**NUMBER:** 23-027-15**GROUP:** Body**DATE:** June 20, 2015

Rear Door Rattle Noise

2014	(VF)	Ram Pro Master (NAFTA)
------	------	---------------------------

Fig. 1 Left Rear Door Lower Latch

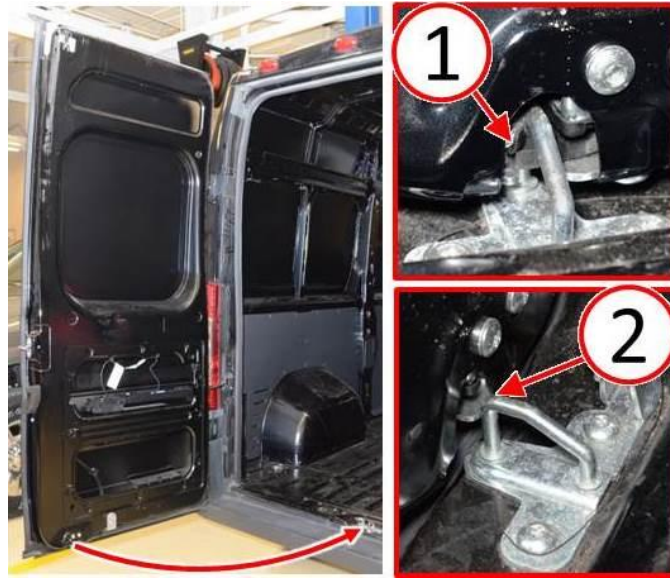
The customer may describe a rear door rattle noise and/or a rear door lower latch not working properly. An example of a properly functioning latch (1) and malfunctioning latch (2) are shown in ([Fig. 1](#)).

1 - Proper Latch Operation - Latch Fully Engaged With Door Closed

2 - Latch Malfunction - Latch Not Engaged With Door Closed

1. Replace both right and left rear door upper latches. Refer to the detailed service procedures available in DealerCONNECT> TechCONNECT under: Service Info> 23 - Body> Doors - Rear> LATCH, Door, Rear Upper> Removal/Installation.
2. Replace the rear door lower latch. Refer to the detailed service procedures available in DealerCONNECT> TechCONNECT under: Service Info> 23 - Body> Doors - Rear> LATCH, Door, Rear Lower> Removal/Installation.
3. Replace the rear door center latch striker and fasteners. Refer to the detailed service procedures available in DealerCONNECT> TechCONNECT under: Service Info> 23 - Body> Doors - Rear> STRIKER, Door Latch> CENTER> Removal/Installation.
